# UNITED STATES PATENT AND TRADEMARK OFFICE

10/669,576

<b>Office Action Summary</b>	<b>Application No.</b> 10/669,576	<b>Applicant(s)</b> HOCHRAINER ET AL.	
	<b>Examiner</b> Teena Mitchell	<b>Art Unit</b> 3771

## **DETAILED ACTION**

FIG. 12B

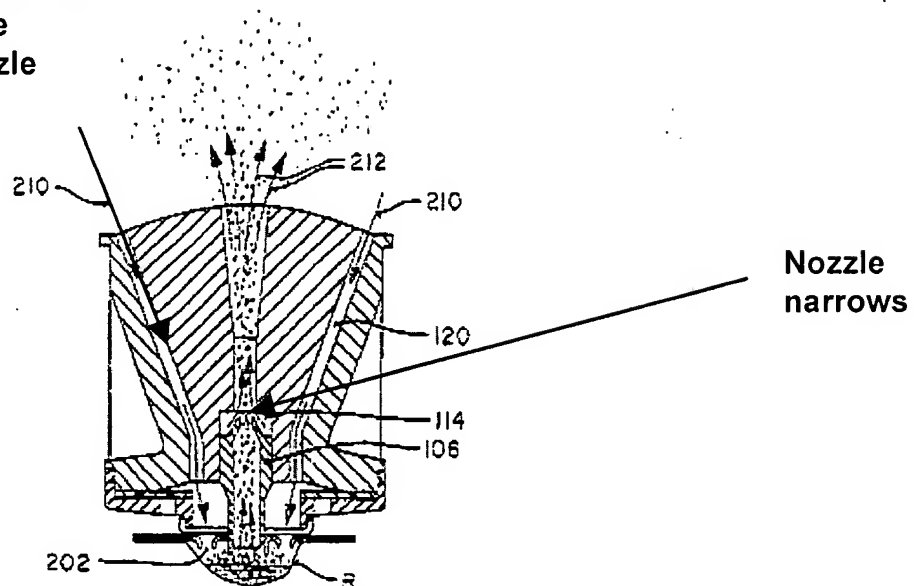
Smith in a dry powder inhaler discloses a mouthpiece (32) for dispensing pharmaceutical drug formulations, a Laval nozzle communicating with the mouthpiece (at 14 and where the nozzle narrows (note illustration of Fig. 12B below), a device for supplying a powder formulation in communication with the Laval nozzle (342), an auxiliary energy source in the form of a pressure medium system (338, 390) in communication with the device for supplying the powder formulation, upon activation of the pressure medium system a gaseous pressure medium is released into the device for supplying the powder formulation and forms an aerosol with the powder formulation in such a way that the powder particles are present in dispersed form within the gaseous pressure medium prior to entering the Laval nozzle entering the mouthpiece and leaving the inhaler.

Gas enters and  
flows into the  
powder prior to  
exiting the  
Laval nozzle
